**AGENDA
HISTORIC DISTRICT COUNCIL
SPECIAL MEETING
MAY 24, 2018
5:00 PM
CITY HALL COMMISSION CHAMBERS
204 ASH STREET
FERNANDINA BEACH, FL 32034**

Owner/Applicant:	Steve Skidmore				
Property Address:	327 N. 4th Street				
Requested action:	Certificate of Approval (COA) to Amend COA to add a drive at front yard and alter design of railings at top of accessory structure stairs				
Current zoning:	R-2				
FLUM land use category:	Medium Density Residential				
Existing uses on the site:	Single-Family Residential				
FL Master Site File #	N/A				
Year Built:	N/A				
Contributing Status:	Non-Contributing				
Adjacent Properties:	North	Single-Family Residential	R-2		
	South	Vacant	R-2		
	East	Vacant	R-2		
	West	Vacant	R-2

HISTORIC DISTRICT COUNCIL STAFF REPORT
HDC 2018-15
MAY 24, 2018

Driveway/ Railing Designs

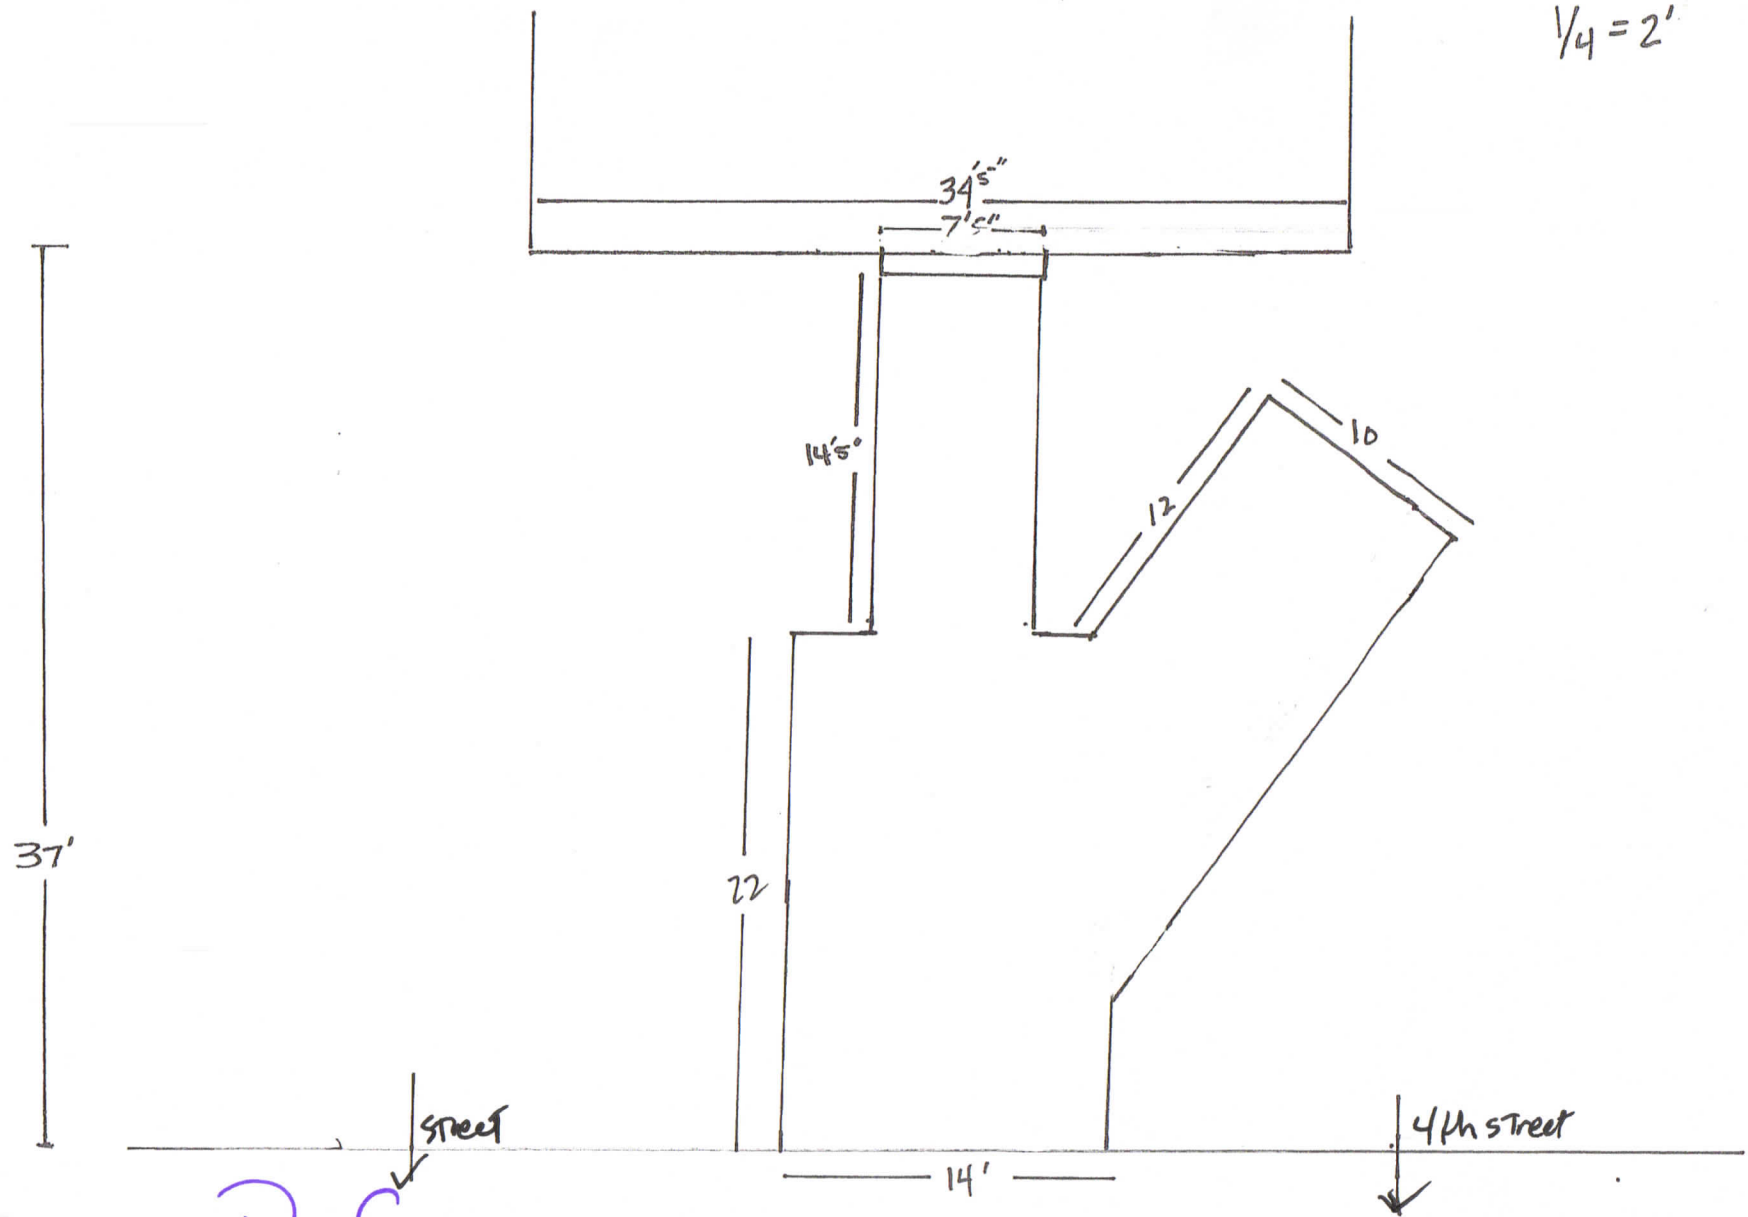
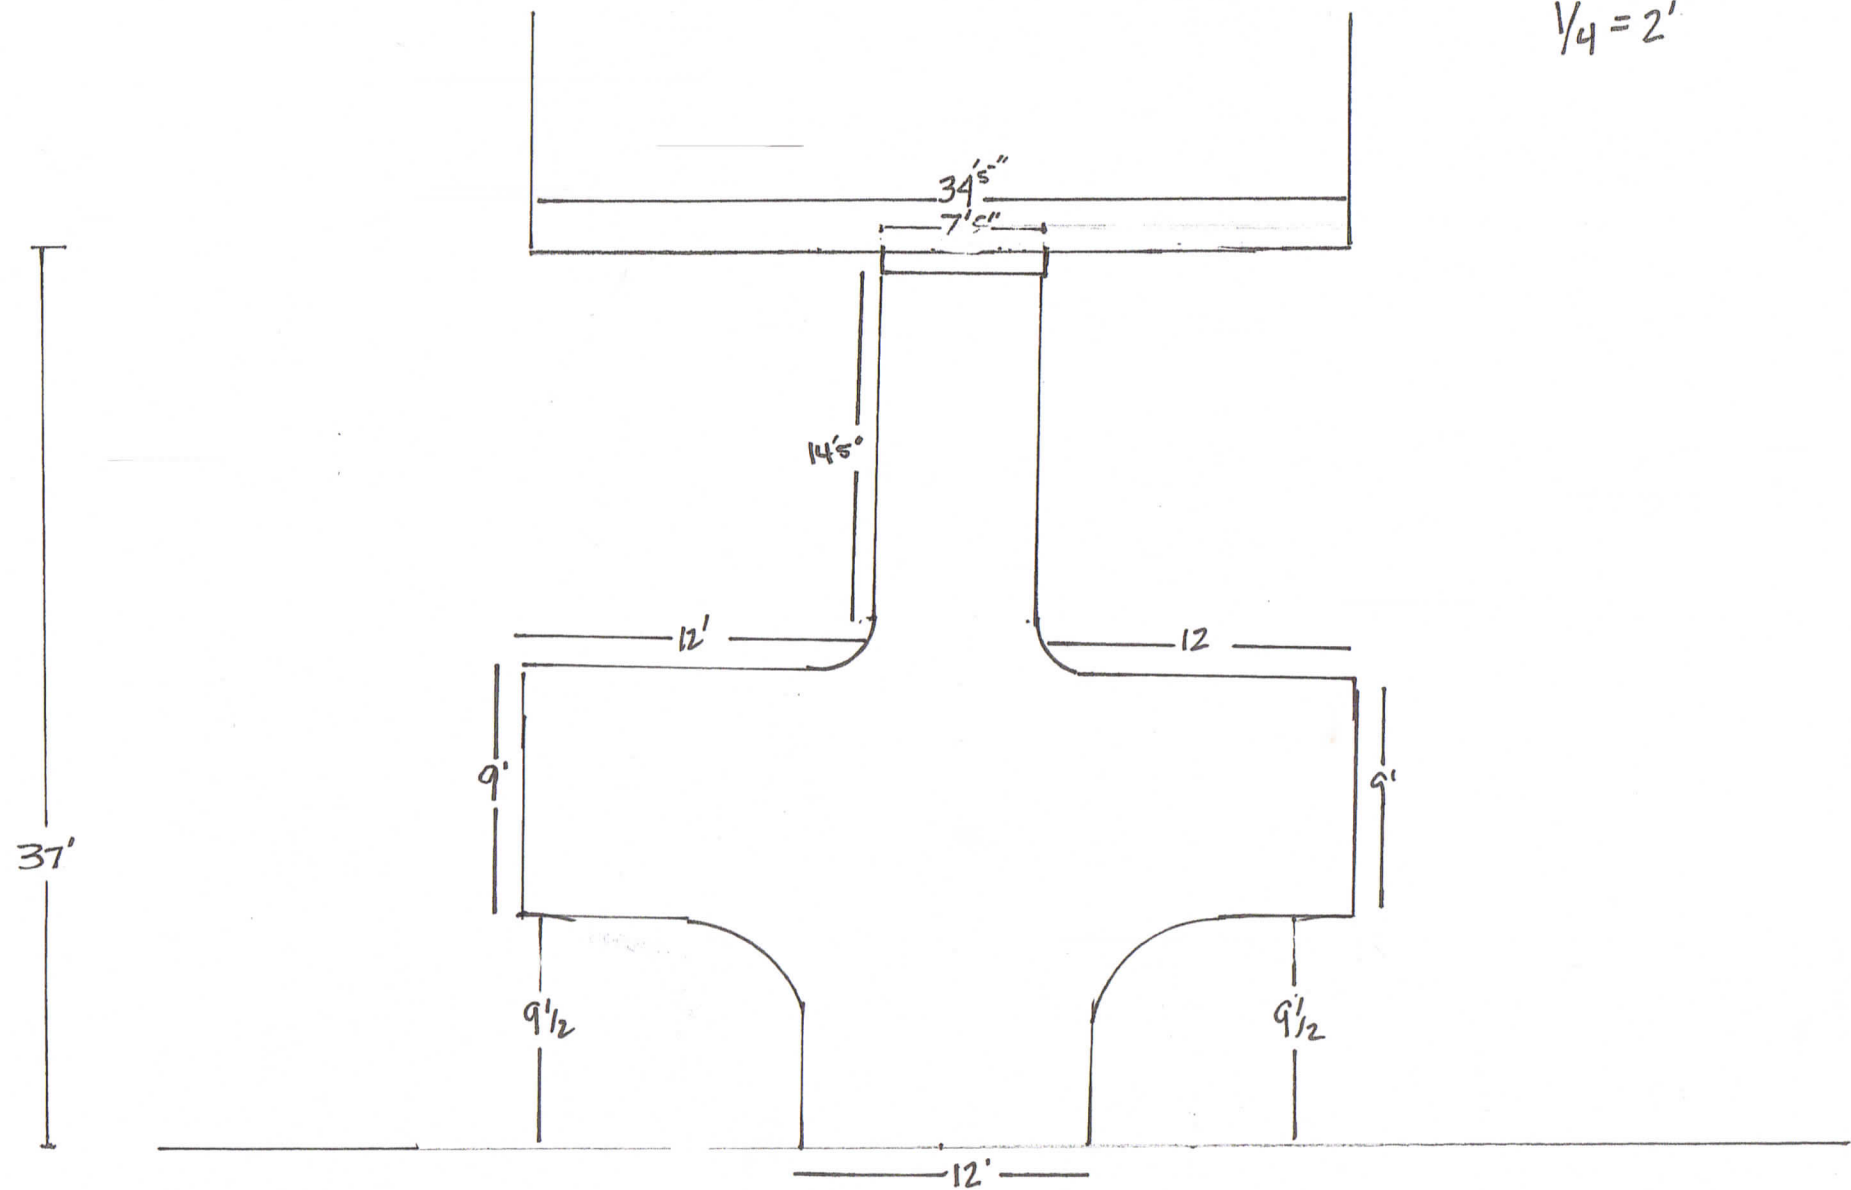
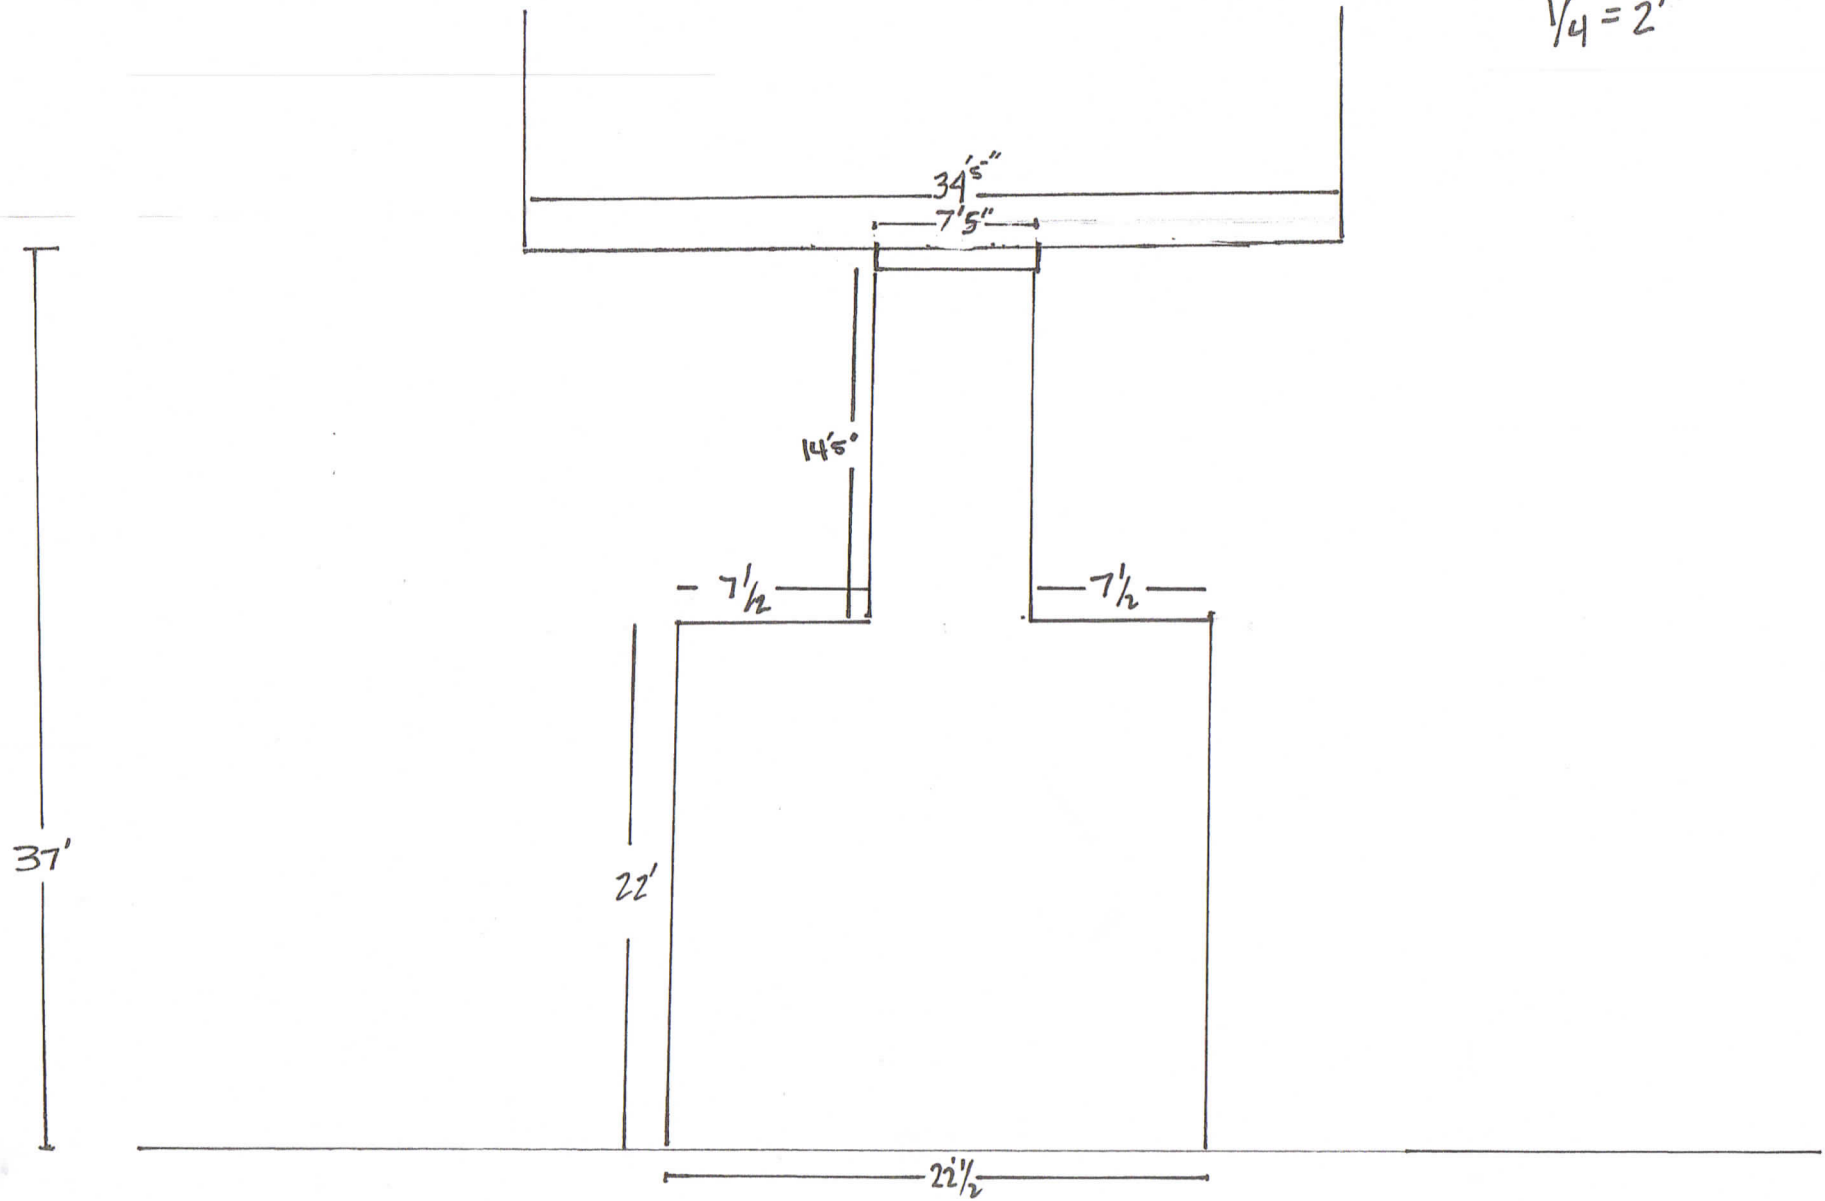
Member Pozzetta discussed the half-wall elements, and reducing those to the minimum needed to keep water off the landing, and replace with railing where possible to increase the openness of the area. Mr. Skidmore asked for more clarification. Member Morrison reiterated that a combination of the half-wall and railing might be acceptable, and railing all around the porch.

Member Erickson thought that the circular drive was inappropriate for this house and the neighborhood. Member Spino stated that the neighbors all have straight driveways, and the way the house was originally approved, there was a walkway from the street and garage on the 4th Street side. While there is some traffic, it wouldn't be considered busy. Member Conway was concerned about the variance needed for the driveway. Chair Harrison asked Mr. Cumella to clarify, and he stated that he suggested the applicant review the questions asked of a variance to show special circumstances to justify the driveway, but it is not a variance. Member Conway stated she did not see a special circumstance.

The applicant is proposing to add a paver driveway to the front yard of the property. The applicant has submitted multiple designs and has indicated their preferred design.

The applicant is also seeking to change the design of the railings at the top of the exterior staircase to the accessory dwelling. The board had previously approved a change that required the half-wall to be solid for no more than 1ft. Due to the dimensions of the floor, the applicant is proposing an alteration which will better work with the current construction and achieve the intention of giving this space more visual openness from the front and rear.

A motion was made by Member Pozzetta, seconded by Member Spino, to approve HDC 2016-32 with the following conditions: that exterior muntins be added to the windows, that a single color paint be used on the house, that the rear yard fence be a maximum of six feet high with previously approved design, that the HDC has approved moving the HVAC and the addition of the rear window, that the circular front drive be removed and the original walkway added as previously approved, that the stair landing wall between the home and accessory structure be reduced to one foot and open railing be installed to code requirement; and that the HDC make the following the findings of fact and conclusions of law part of the record this Amendment to case HDC 2016-32 with comments is substantially compliant with the Land Development Code, the Historic Downtown District Guidelines, and the Secretary of Interior Standards to warrant approval at this time. Vote upon passage of the motion was taken by ayes and nays and being all ayes, carried.

FOUNDATION PLAN - PROPOSED

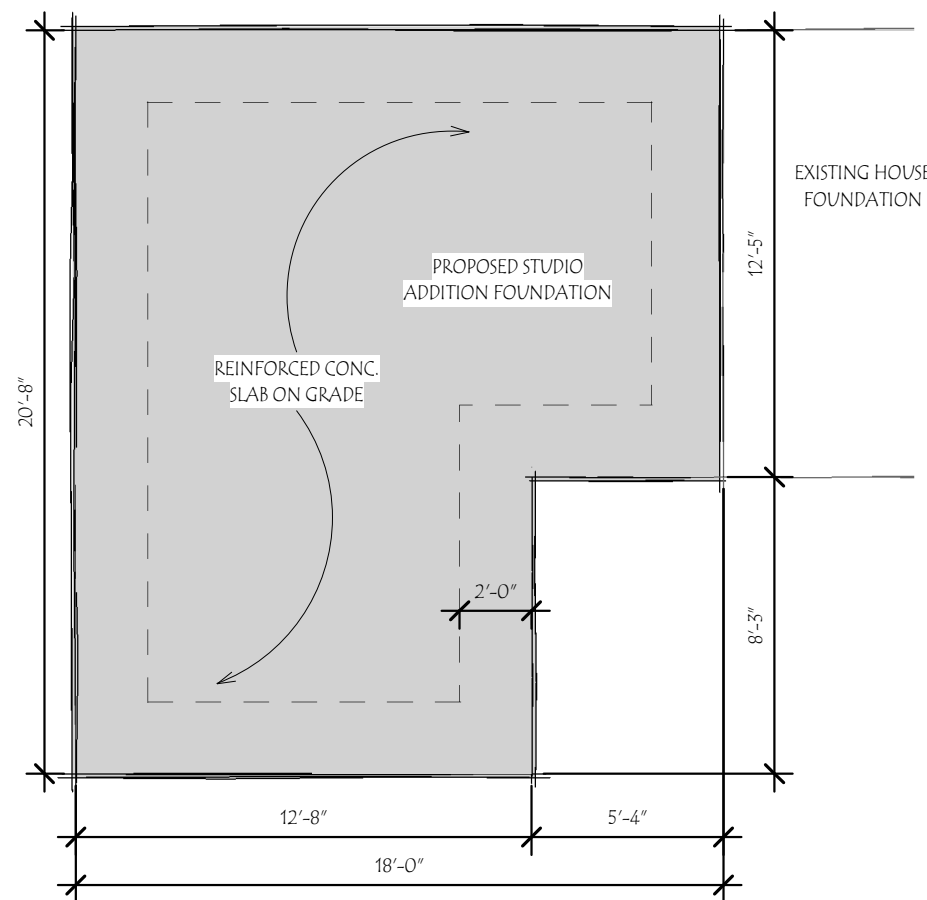
Member Pozzetta asked about the foundation plan for the appearance of piers and requested to see one.

Member Pozzetta looked at the foundation plan as it did not show articulation, which came up last month. He feels that the foundation plan should show piers or appearance of piers, and would not approve until that is shown. He also wanted detail and materials on the louvers.
